PLUTONIUM TRANSPORTS IN FRANCE Safety and Security Concerns over the FS47 Transportation Cask

21 September 2004

This briefing note reviews the IRSN rebuttal in terms of recent technical evaluations, technical evidence submitted in the United States, and technical papers relating the performance of the FS47 cask design when subject to credible accident and potential terrorist attack conditions.

Figure 2: Real scale drop test (left) and computer simulation (right) to assess the FS47 behaviour in potential handling accidents

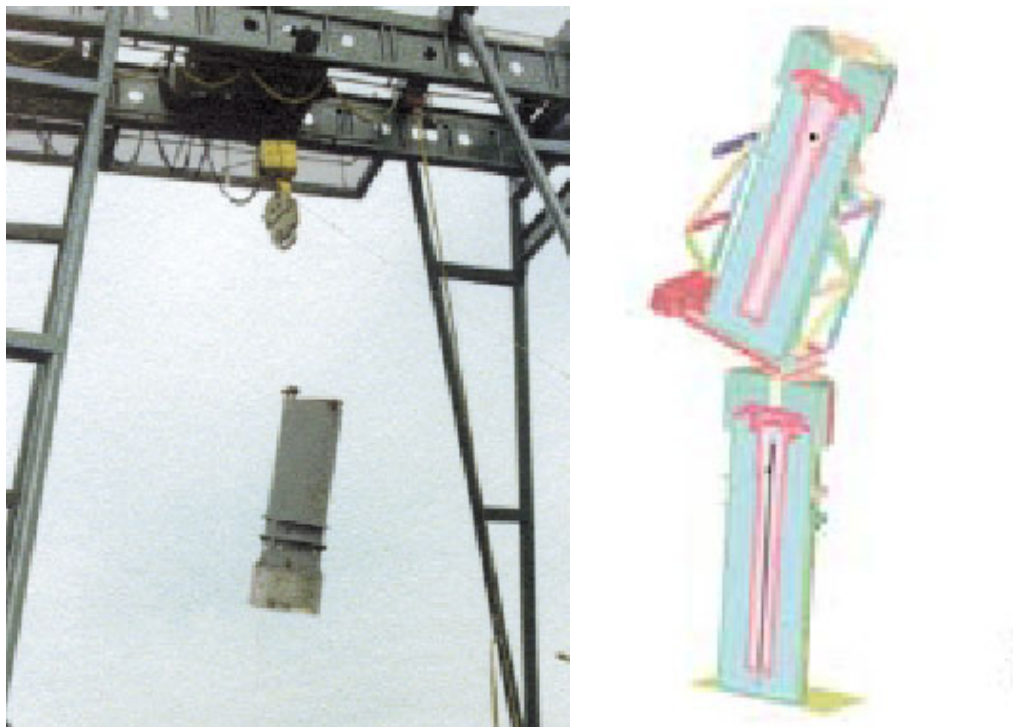
Impact Performance: So far as simulating real accident and terrorist incident conditions, the IRSN tests and modelled simulations are somewhat contrived. For example, IRSN does not consider fully perforating impacts; the impact simulations are applied to longitudinal impacts with a vertical descent of the cask, with no induced rotation, and the impacts always involved cushioning by the shock absorber end-cap.

The general theme of past IRSN test and modelling programmes clearly relates to handling mishaps, particularly during craneage, and not to road traffic accident situations in which the force circumstances are likely to be more complex and of higher magnitude. In particular, the performance of a group of casks when racked for transport (Figure 3) under transverse impact has not been determined at all.

Figure 5: Impact of a moderate efficiency conical shaped charge: penetration of the cask (above) and interaction with the nuclear material (below)

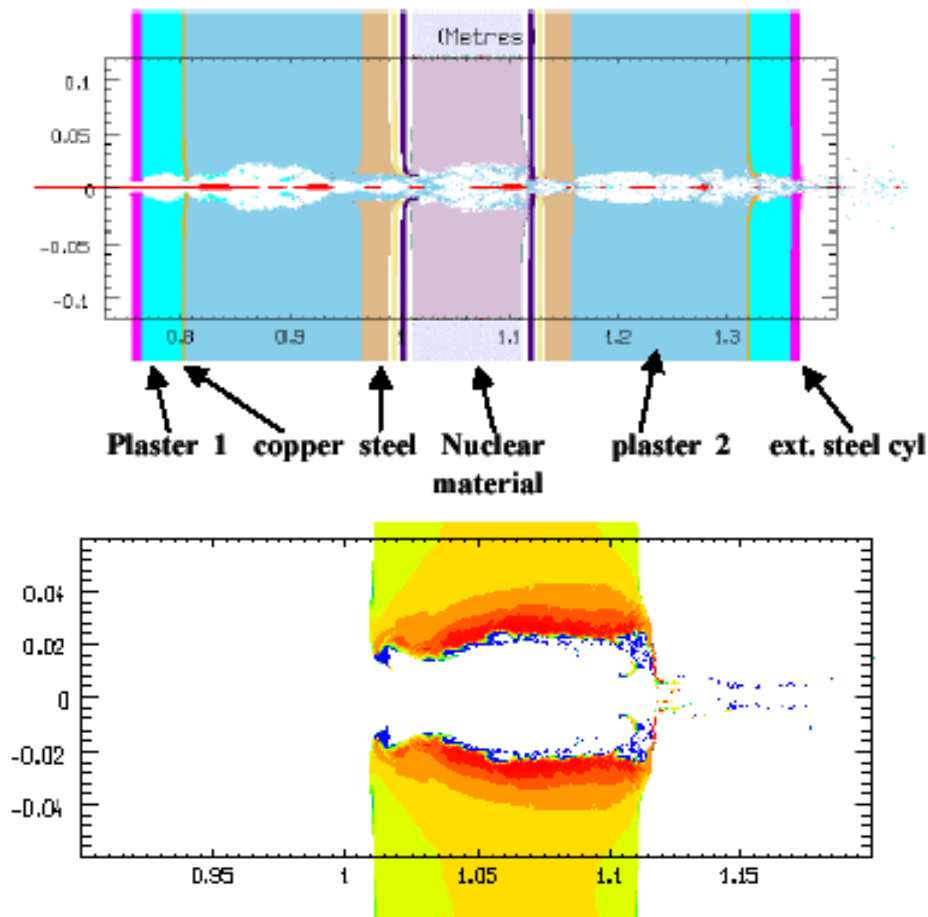
There is far too little detail in the IRSN paper about the assumptions establishing the CSC2 munitions and no results whatsoever are given of the numerical modelling other than the comment “*these tests showed that the CSC1 passes through the first cask and slightly damages the second one without reaching its inner cylinder. An estimation of the quantity of nuclear material dragged out of the experimental device has been obtained . . . calculations with CSC2 have shown the increase of damage to the casks (mainly the second one) and justify the need for dedicated experiments*”.

The outcome of the numerical simulation of CSC1 are presented in **Figure 5**. Though difficult to interpret, they clearly indicate that a conical shaped charge projected against the cask perpendicular to its axis would penetrate the outer and intermediate shells, this jet passing through the inner cylinder and passing out the backside of the cask, therefore removing a volume of the plutonium oxide powder. Nevertheless, the IRSN paper introduces the caveat that “*the diameter of penetration is underestimated and the removal of nuclear material is overestimated by the calculation (the latter being related with the fact that the nuclear material removed from the inner cylinder may reach the outside)*”⁵¹. So, according to IRSN logic, a larger breach in the side of the inner container results in less scavenging of PuO₂ from within – how odd !
